Office Action Summary	Application No. 10/645,055	Applicant(s) DEVENS ET AL.	
	Examiner VICTORIA P. CAMPBELL	Art Unit 3763

DETAILED ACTION

This is the second Office Action following the Request for Continued Examination based on the 10/645055 application filed August 21, 2003. Claims 1-5, 8, 10, 12, 14, 17, 43, 44, 46, and 47 as amended are currently pending and considered below.

Fig. 2b

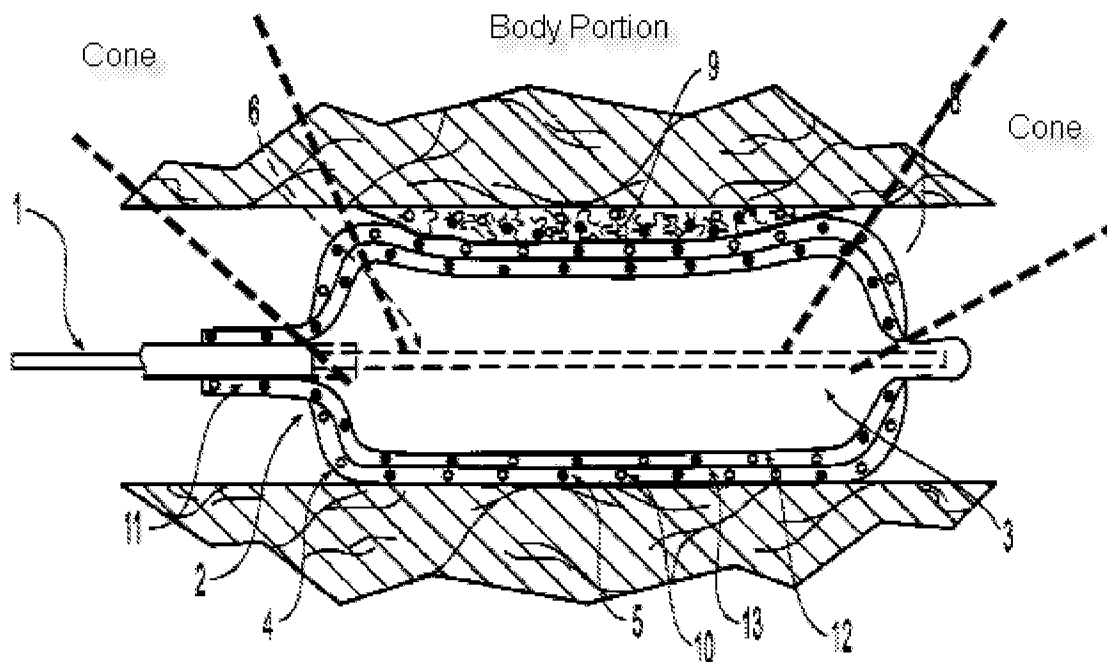
Regarding claims 1-3, 8, 10, 12, and 14, Ding et al disclose a medical device comprising a balloon (3) comprising a first portion having a first length (2), and a second portion disposed on the first portion having a second length (4), wherein the second portion defines an outer surface of the balloon; wherein the first portion varies in thickness along the first length and the second portion varies in thickness along the second length (Figs. 2a, 2b; see right hand side), wherein the balloon has a body

portion and a cone portion and wherein the first portion has a great thickness at the body portion than at the cone portion (Fig. 2b; the body portion of the first portion is thicker than the tapered portion of the cone; see Fig. 2b reproduced below for clarification).

Ding et al further disclose that the first and second portions have different compositions (the first portion is a reservoir, the second is a sponge material), that the second portion is disposed substantially entirely on the first portion, that the thickness of the first and second portions is generally constant in the cone portion (the tapering of the portions takes place only at the most extreme end of the cone portions, and therefore the thickness is maintained along substantially the entire length), and that the portions extend substantially the entire length of the balloon (Figs. 2a and 2b).

Regarding claim 44, Ding et al also disclose that the balloon includes a tapered portion (see “cone” in the labeled Fig. 2b reproduced above), but do not explicitly teach or disclose that the body and tapered portions have different stiffness. Because the first and second layers taper sharply at the end of the tapered portion, the examiner believes this would impart additional flexibility to the tapered portion because, in general, when the thickness of a material is decreased, its flexibility is increased, and therefore its stiffness is decreased.
